Project Address: 310-402 Cottage Grove Road, 904 Dempsey Road
Application Type: Revised Preliminary and Final Plat
Legistar File ID # 32131
Prepared By: Heather Stouder, AICP, Planning Division
Report Includes Comments from other City Agencies, as noted

Requested Action: The applicant requests approval of a revision to a preliminary and final Royster Corners plat to subdivide the 32.9-acre property for the creation of 60 lots totaling 22.8 acres, 3 outlots for stormwater management and greenspace totaling 4.4 acres, and the dedication of public streets within.

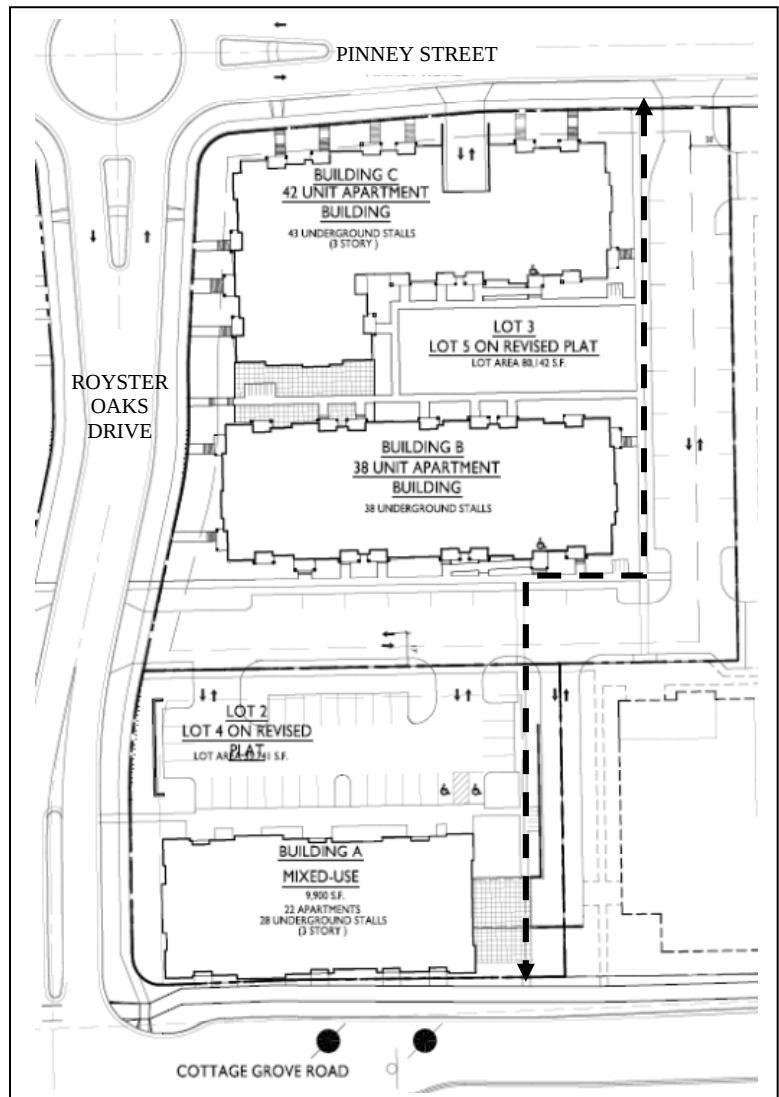
Staff carefully considered the proposal to eliminate this street, which would have been located mid-block between Royster Oaks Drive and Dempsey Road, separating the mixed-use and employment portions of the site. Without a street, the length of the resulting block between Royster Oaks Drive and Dempsey Road is approximately 600 feet, which is the length of a typical urban block. If this stretch were significantly longer, it would be difficult to move forward without a street connection here. However, staff believes that so long as a north-south pedestrian connection is maintained somewhere between Royster Oaks Drive and Dempsey Road through this area to provide more direct access to the commercial, employment, and residential uses and to any future development oriented to Pinney Street, the north-south street proposed for removal is not needed. Staff

notes that the applicant has already provided a pedestrian connection to meet this need within the development proposals currently before the Plan Commission (see graphic below).
